Appl. No.: 10/711,439  
Amdt. Dated: 5/25/2006  
Reply to Office action of: 03/15/2006

**AMENDMENTS TO THE DRAWINGS:**

### REMARKS/ARGUMENTS

Fig. 2

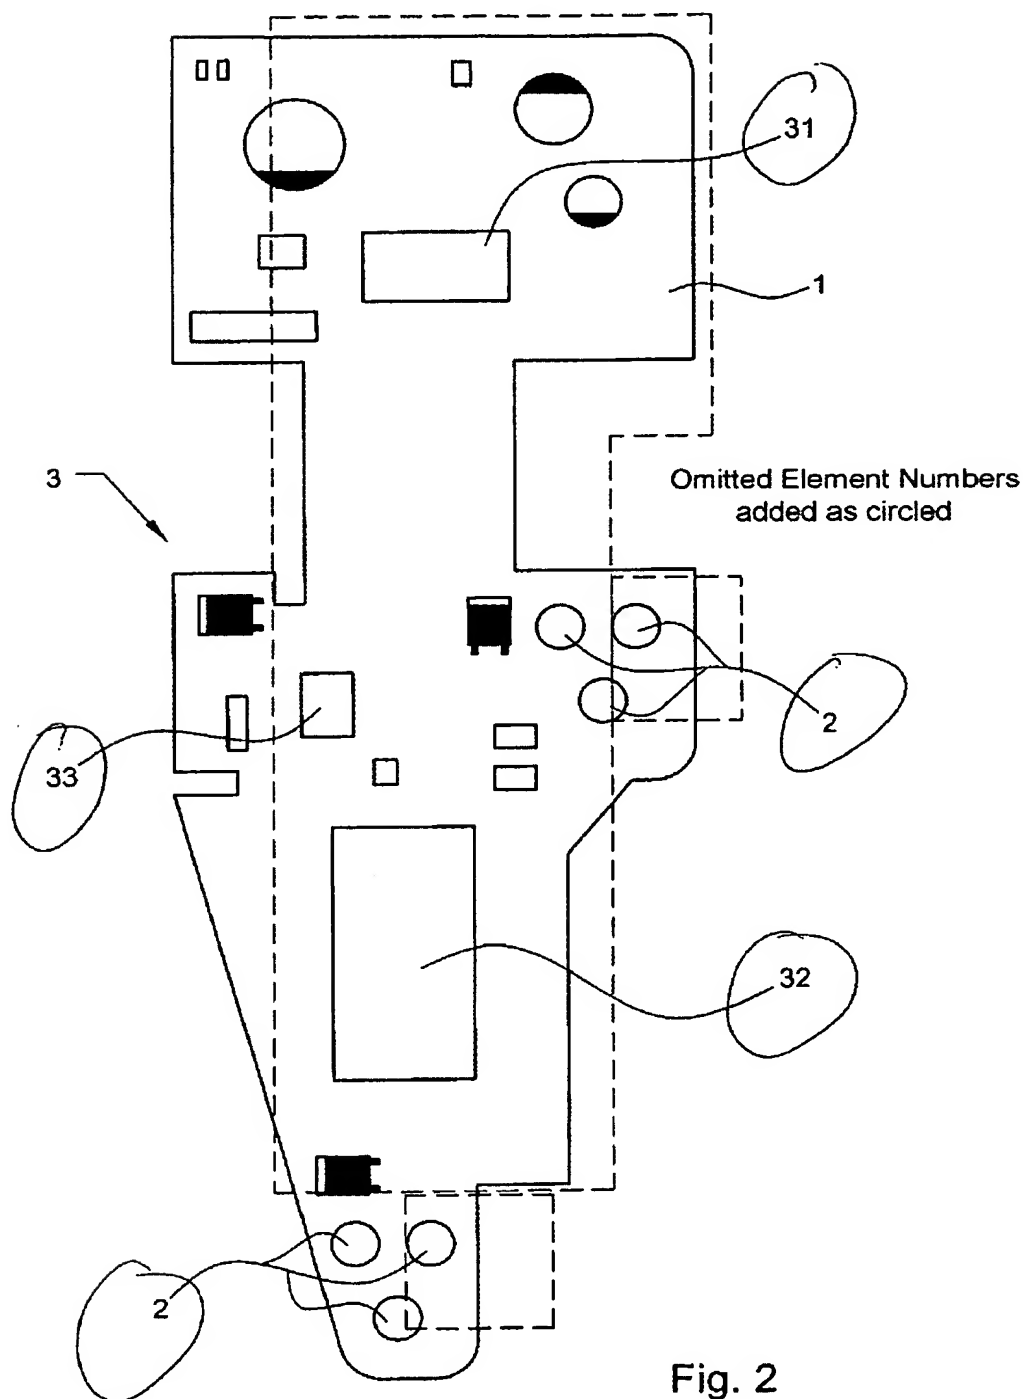
The attached 4 sheets of drawings include changes to Figure 2 and the addition of new Figures 3 – 5. The sheet including Figure 2 replaces the original sheet including Figure 2. In Figure 2 the previously unnumbered elements 2, 31, 32, and 33 have been properly identified. In Figures 3 – 5 the claimed but previously not illustrated features of the claimed invention have been properly illustrated and identified.

The drawings have been amended. Figure 2 has been amended to identify properly all elements of the drawings. New Figures 3 – 5 have been added in response to the Examiner's objection to the drawings not showing all of the claimed elements of Applicant's invention.

The drawings have been objected to for failing to show every feature of the invention specified in the claims. Specifically, the Examiner states:

Therefore, the casing closed with a cover, a computer on board said vehicle, the PWM, the accelerometer, the inclinometer, the humidity sensor and the temperature sensor must be shown or the feature(s) canceled from the claim(s).

Applicant respectfully traverses this objection. In light of the amendments to the drawings to identify clearly all elements of Applicant's claimed invention this objection is now moot and Applicant respectfully requests this objection be removed.
